OIL - TO INTRODUCE A NEW OIL PUMP WITH INCREASED FLOW RATE - CATEGORY CODE 8 -  
MOD.ENG-79-0006

- (1) Aircraft (a) Airbus A320
- (2) Engines (a) V2500-A1 Engines prior to Serial No. V0164

V2500-ENG-79-0006

Oil pump casing assembly - 4A7099 - Sections AA, AB and AC  
Figure 1

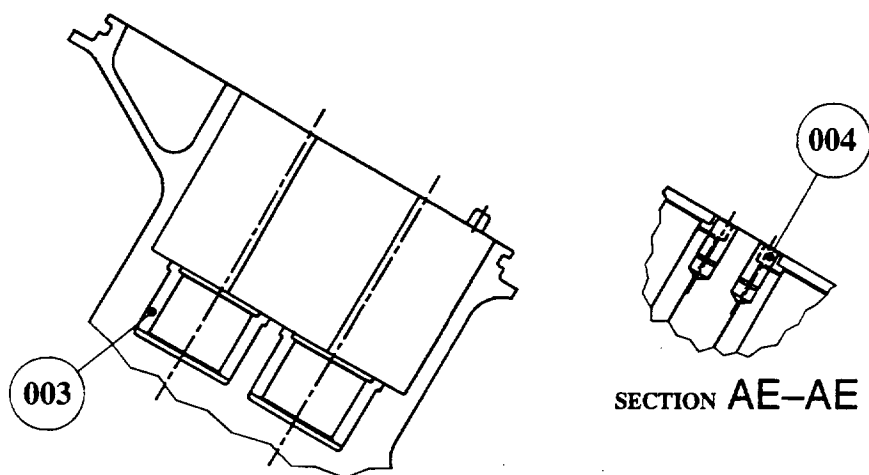
- (2) Disassemble the casing (4B7256) and the cover (4B7227) of the oil pump assembly. For the correct disassembly procedures, refer to the A1/A5 Component Maintenance Manual (CMM), Chapter/Section 79-21-41. (Refer to Figure 1, Section AA-AA).

Oil pump casing assembly - 4B7256 - Section AB  
Figure 2

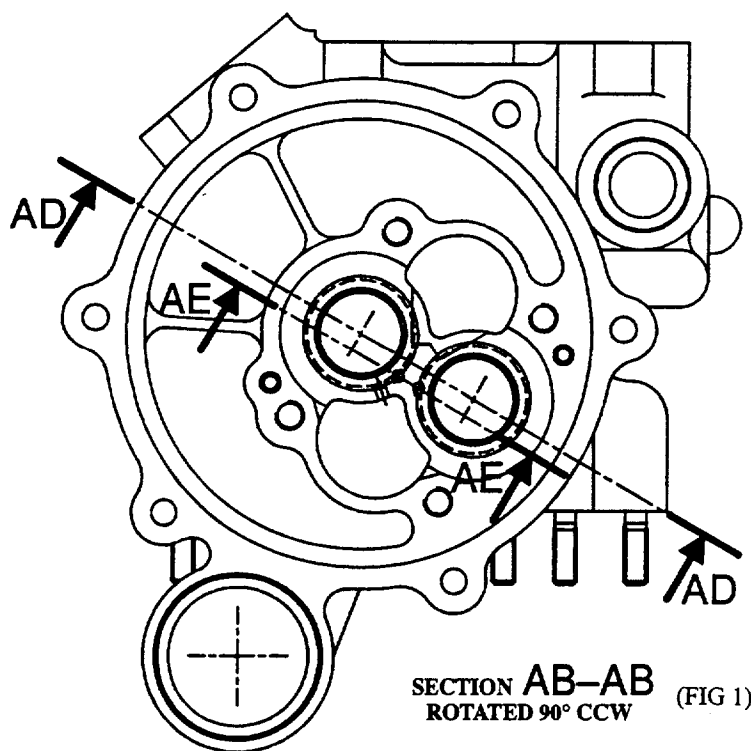
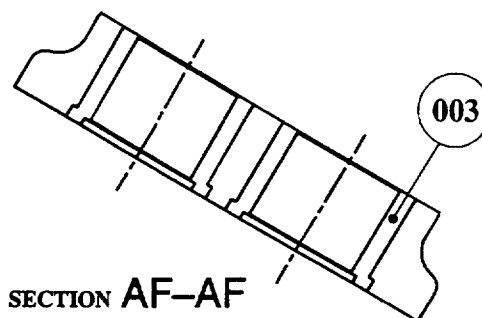
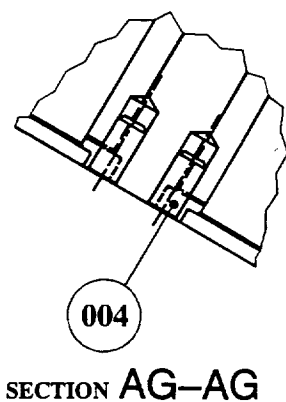
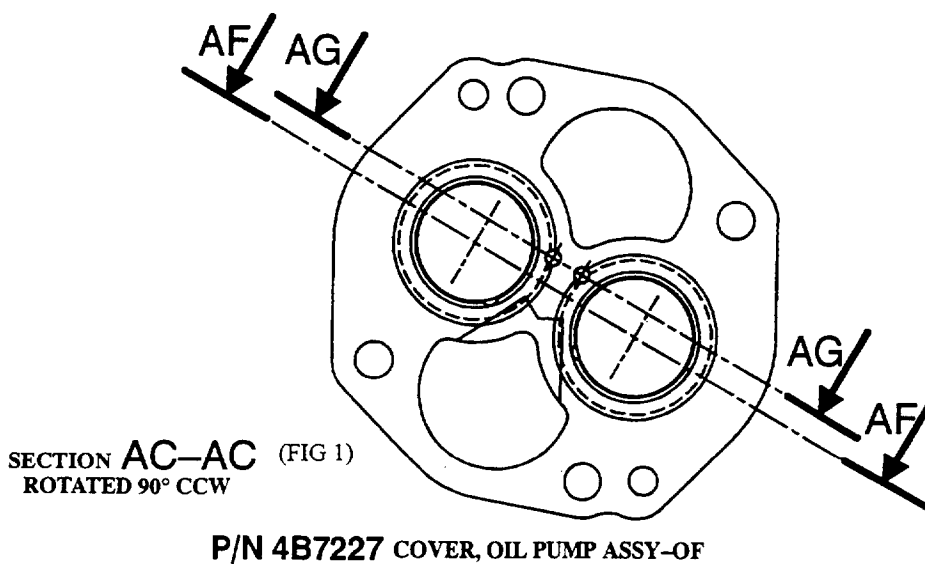
- (3) Remove the two bushes 4P7228 and the two pins 4P7225 from the casing (4B7256) of the oil pump assembly. (Refer to Figure 2, Sections AD-AD and AE-AE).

Oil pump cover assembly - 4B7227 - Section AC  
Figure 3

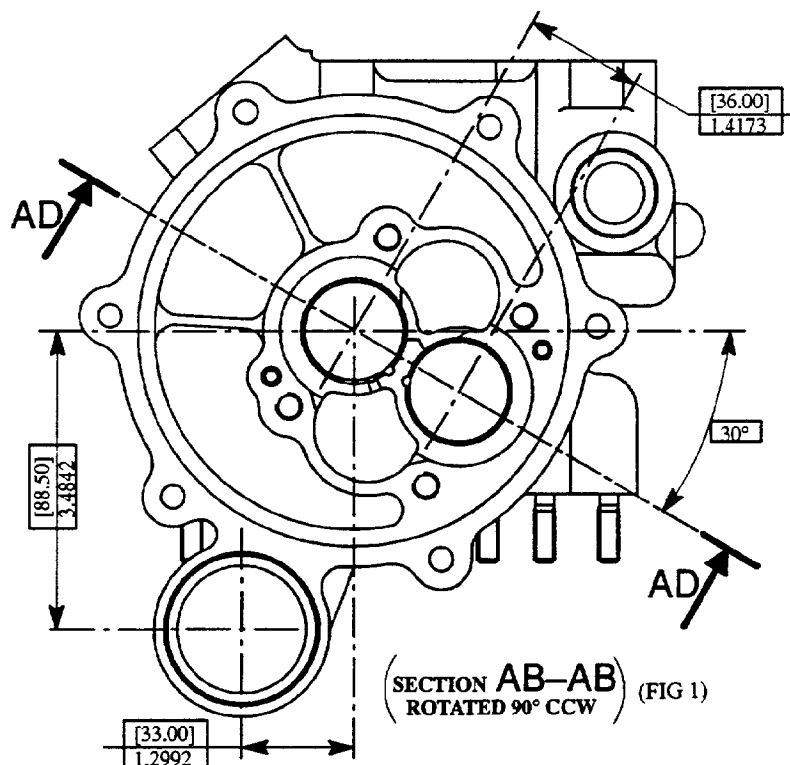
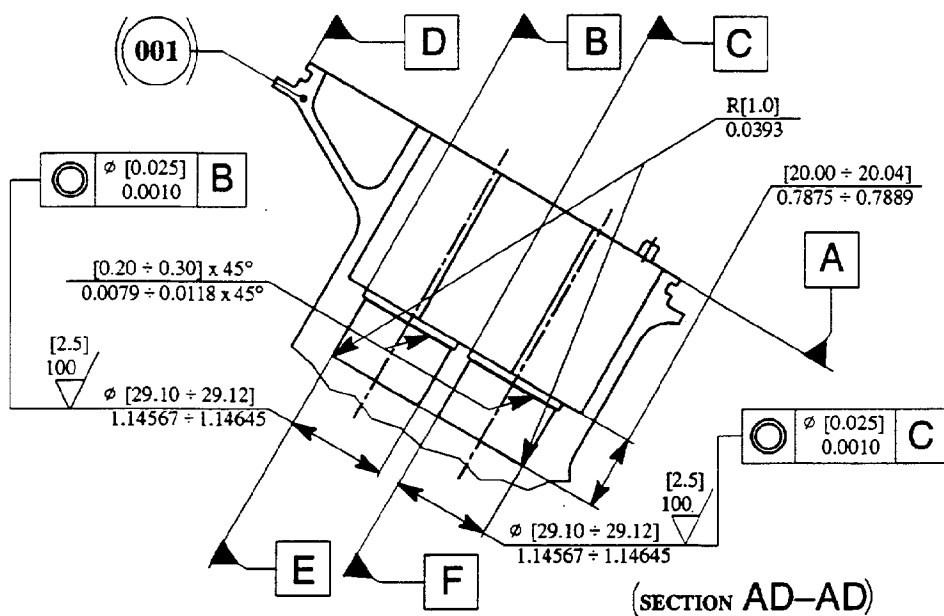
- (4) Remove the two bushes 4P7228 and the two pins 4P7225 from the cover (4B7227) of the oil pump assembly. (Refer to Figure 3, Sections AF-AF and AG-AG).

Oil pump casing assembly - 4B7256 - Section AB  
Figure 6

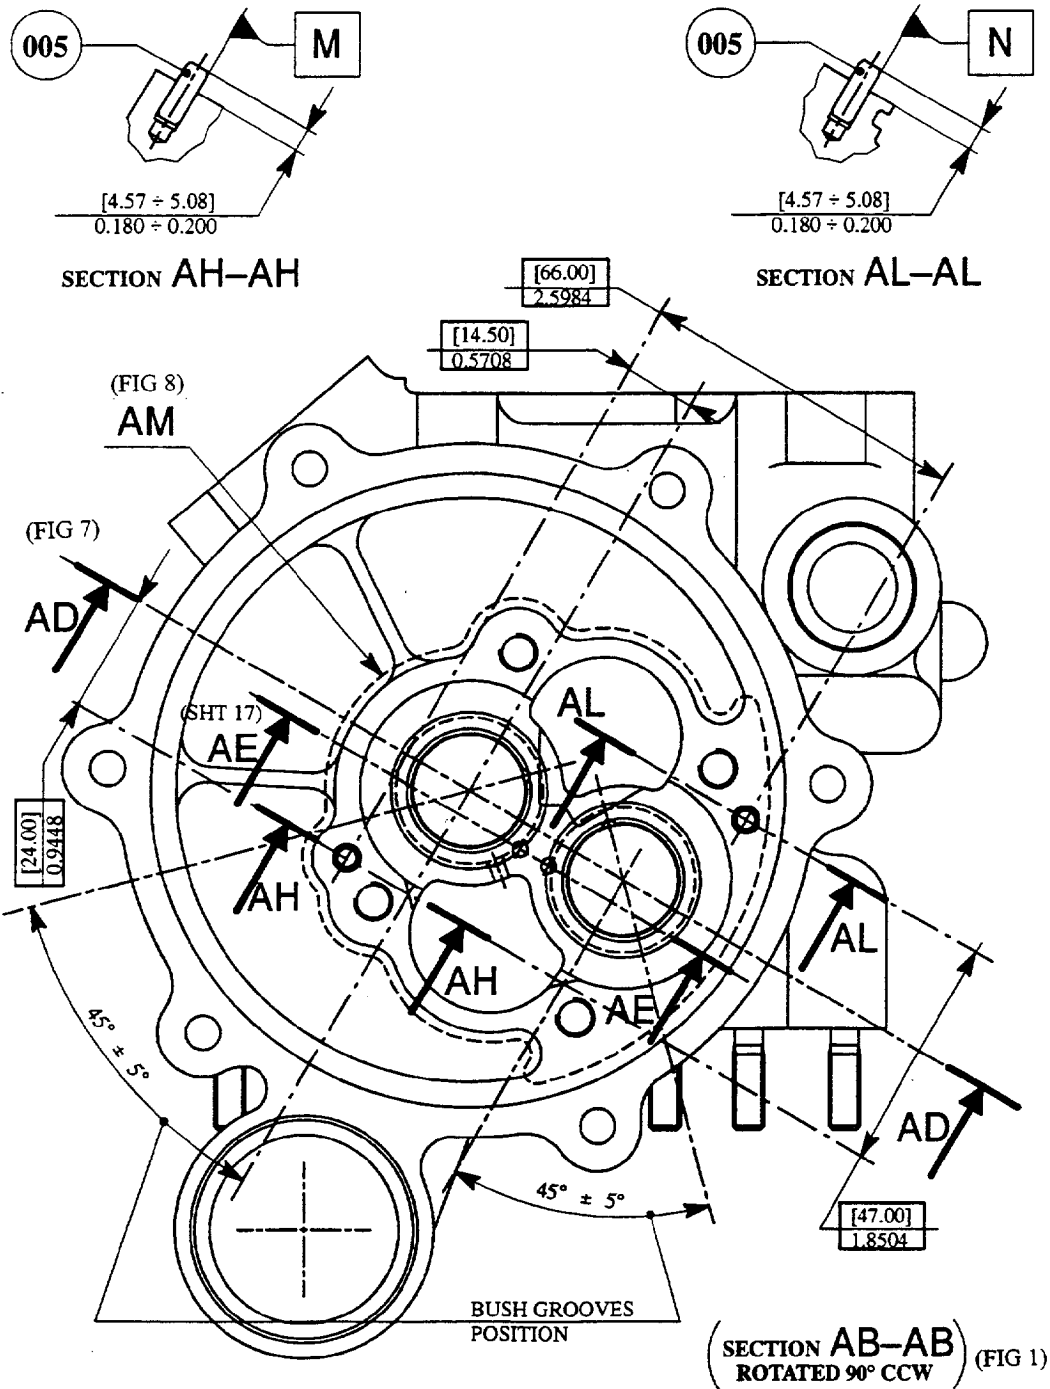
- (5) Machine the two bush seats of the casing 4B7256.
- (6) Machine the two bush seats of the cover 4B7227
- (7) Remove the two alignment pins (4T7918) from the casing 4B7256. Refer to Figure 6, Sections AH-AH and AL-AL.

Oil pump casing assembly - 4B7256 - Sections AD and AE  
Figure 7

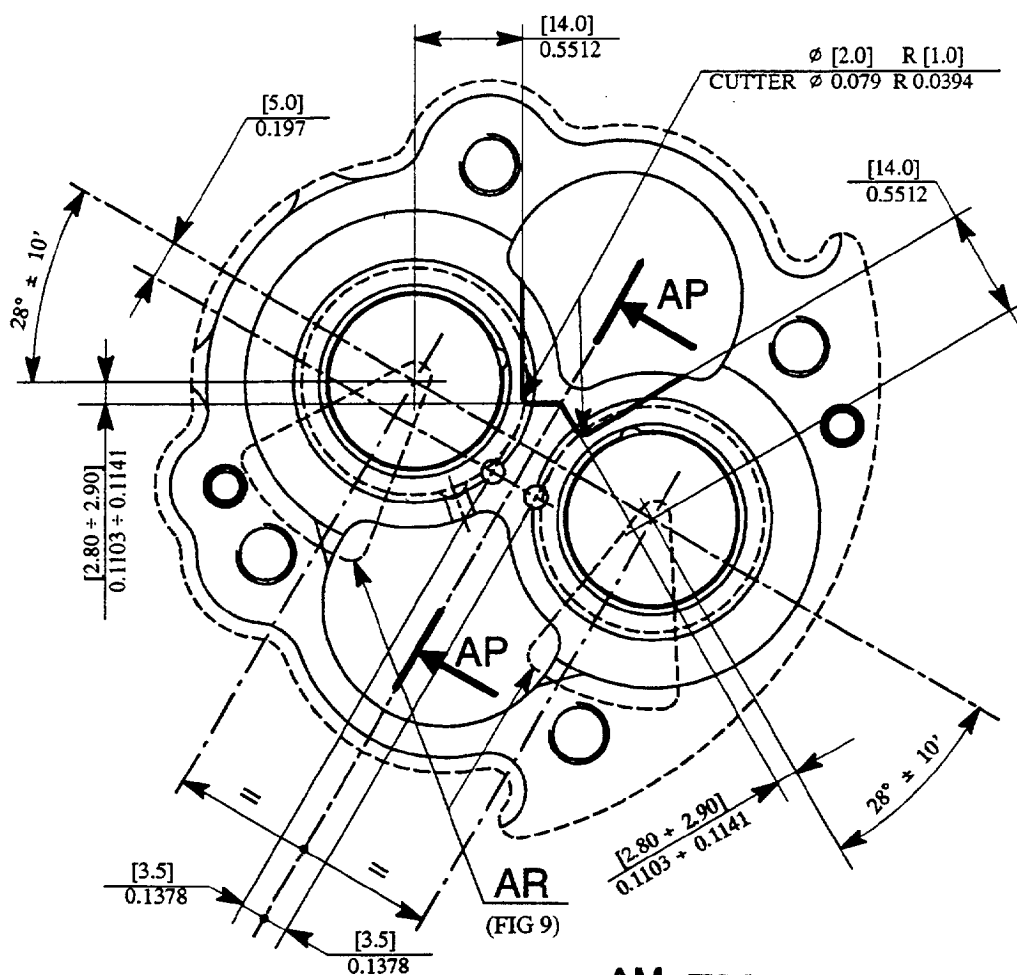
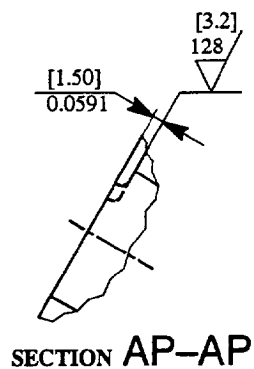
CAUTION: WHEN YOU MACHINE DATUM-A, MAKE SURE THAT DIMENSION\* DOES NOT GO OUT OF LIMITS.

- (8) To get Datum-P of the casing (4B7256), machine Datum-A. Make sure that Dimension\* does not go out of limits. (Refer to Figure 7).
- (9) Install the two new bushes (4P7313) in the casing (4B7256). (Refer to Figure 7, Section AE-AE and Figure 8, detail AM).
- (10) Install the two new alignment pins (4T7918) in the casing (4B7256). (Refer to Figure 6, Sections AH-AH and HL-HL).
- (11) Machine the internal diameter of the two bushes (4P7313) and the internal surfaces of the case. (Refer to Figure 7, Section AD-AD).
- (12) Machine the bottom internal surface of the casing. (Refer to Figure 18, Section AP-AP and detail AM).
- (13) Install the two new bushes 4P7313 in the cover (4B7227), Refer to Figure 10, Section AF-AF.

Oil pump cover assembly - 4B7227 - Sections AC, AF and AG  
Figure 10

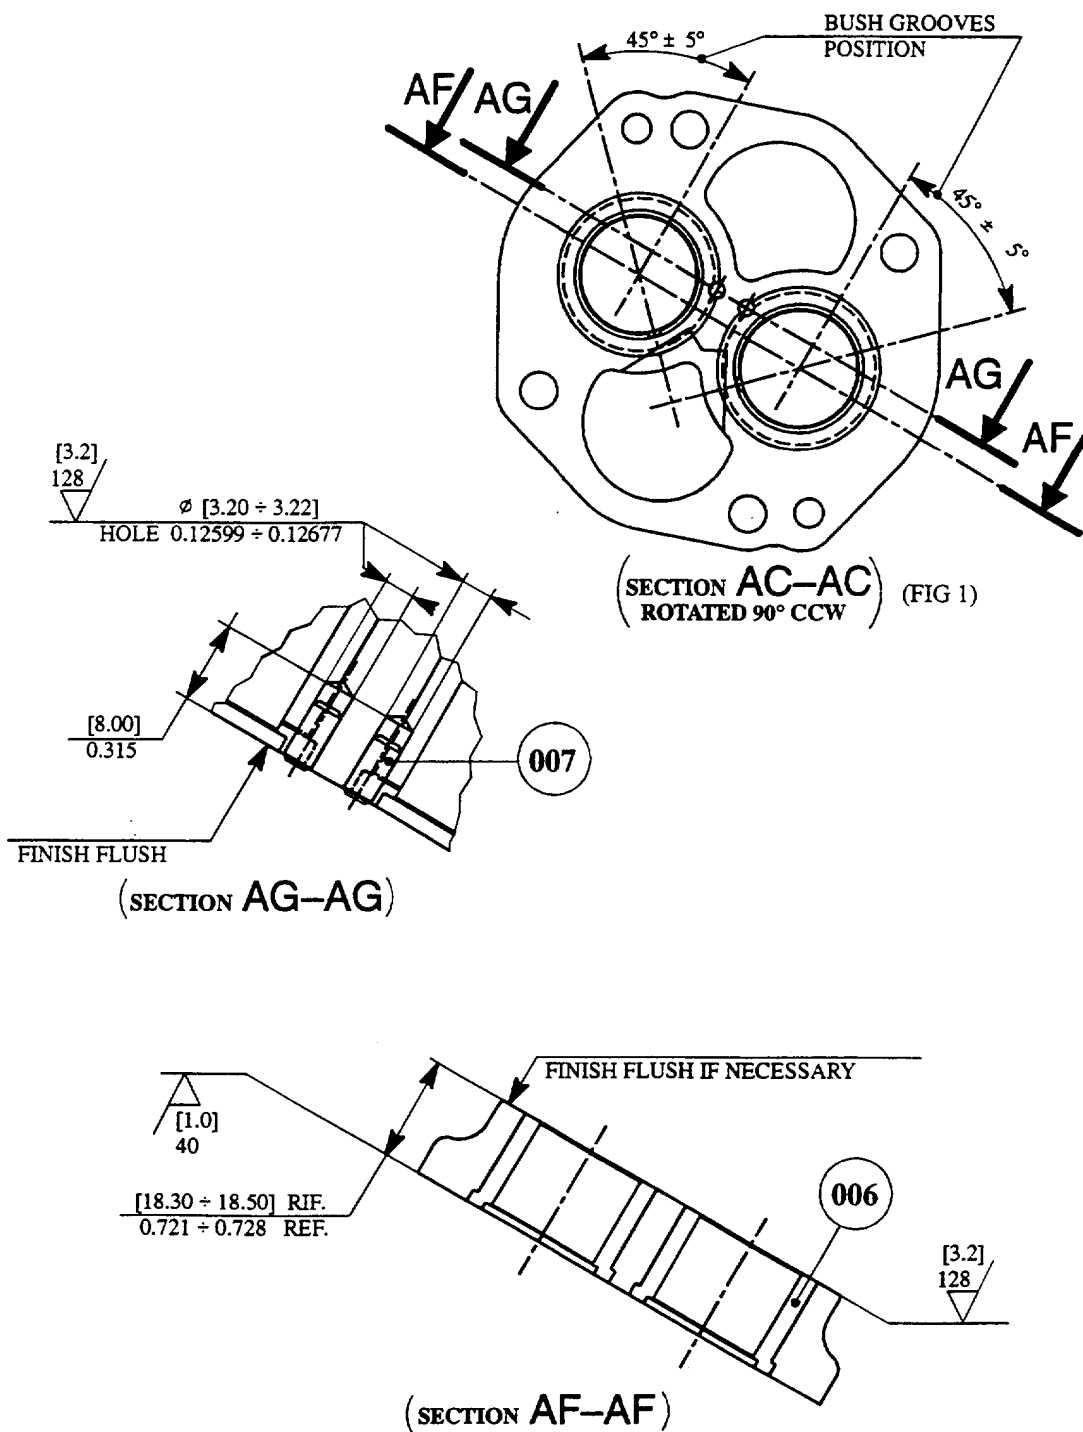
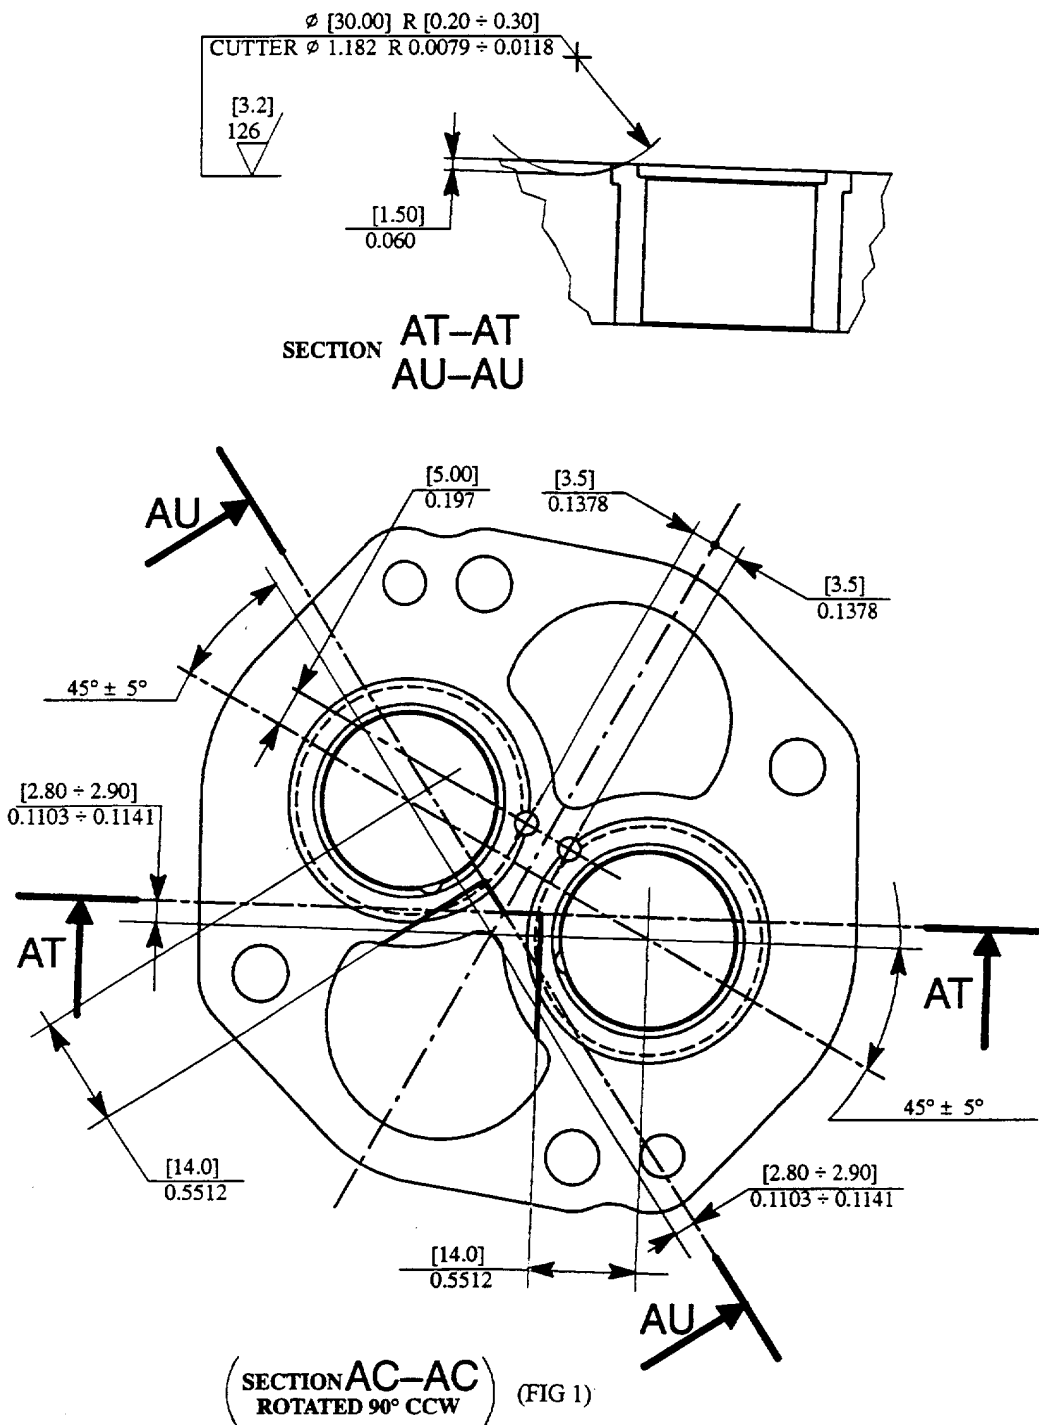
- (14) Drill two pin holes and install the two new pins 4P7311. (Refer to Figure 10, Section AG-AG. and Figure 11, Section AC-AC).
- (15) Flush-finish the two faces of the cover. (Refer to Figure 10, Sections AF-AF and AG-AG).

Oil pump cover assembly - 4B7227 - Section AC, AT and AU  
Figure 11

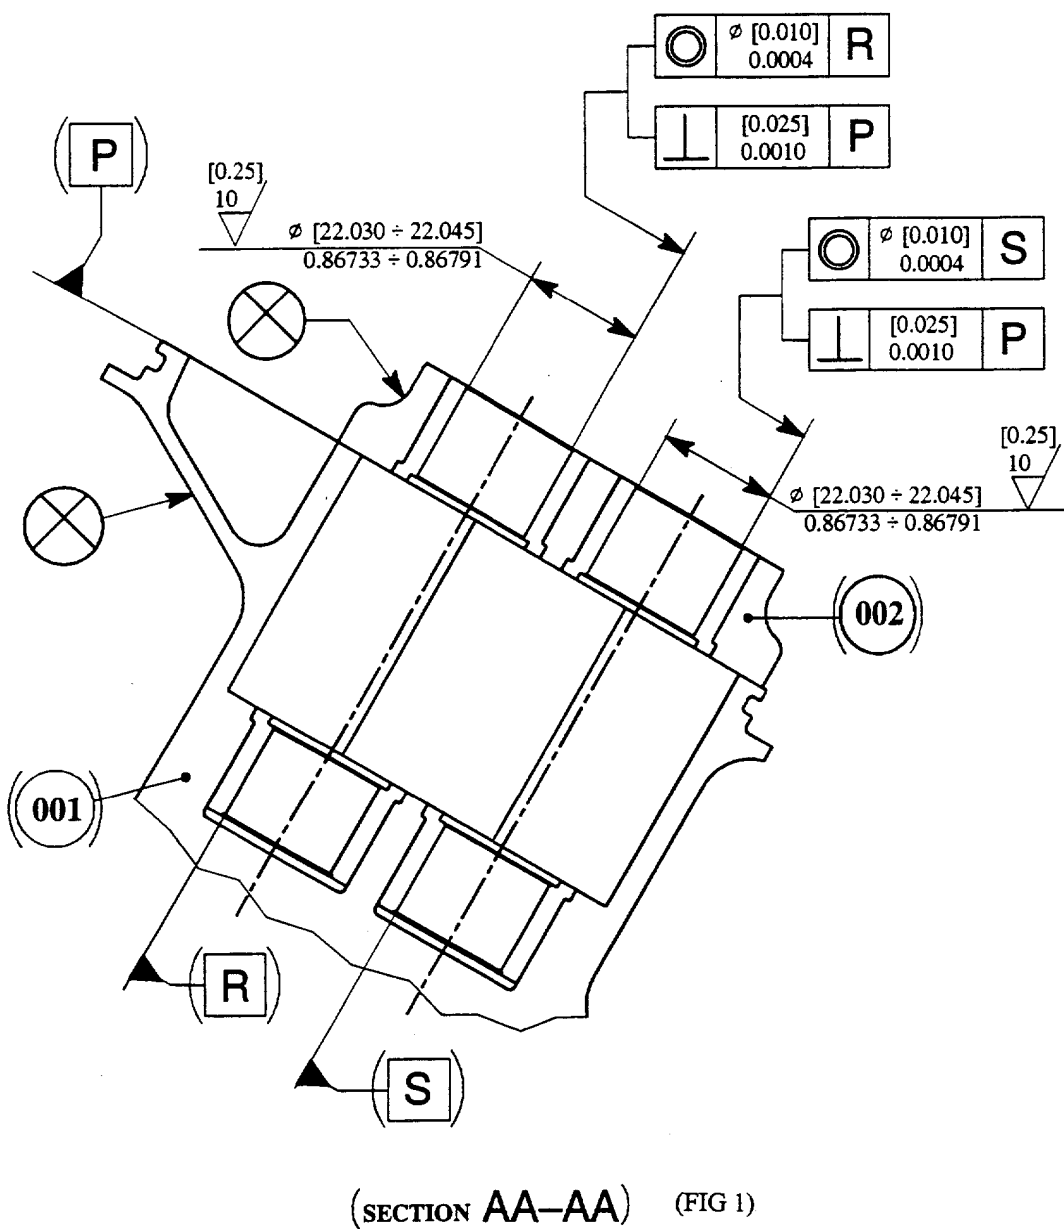
- (16) Machine the face of the cover that touches the casing. (Refer to Figure 11, Sections AC-AC, AT-AT and AU-AU).
- (17) Assemble the machined cover 4B7227 and the casing 4B7256. (Refer to Figure 12, Section AA-AA).
